Rezoning Transportation Analysis

Petition Number: 2025-004

General Location Identifier: 12305403

Revision Log:

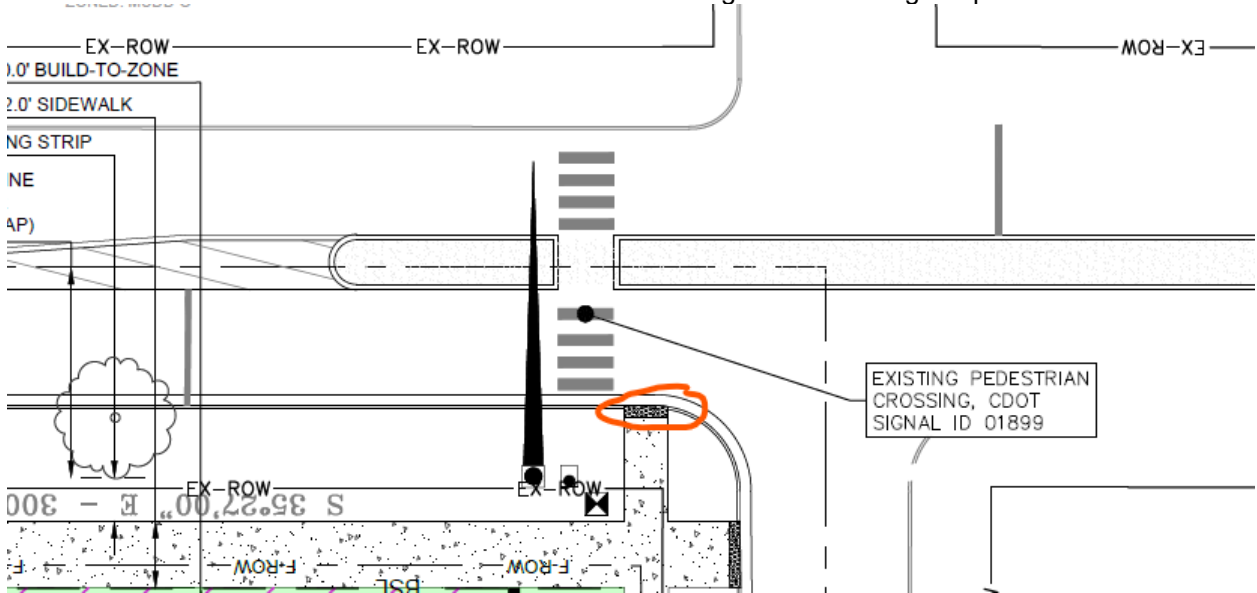
16. **New Comment 11.19.25:** Shift crosswalk shown below to align with receiving ramp.
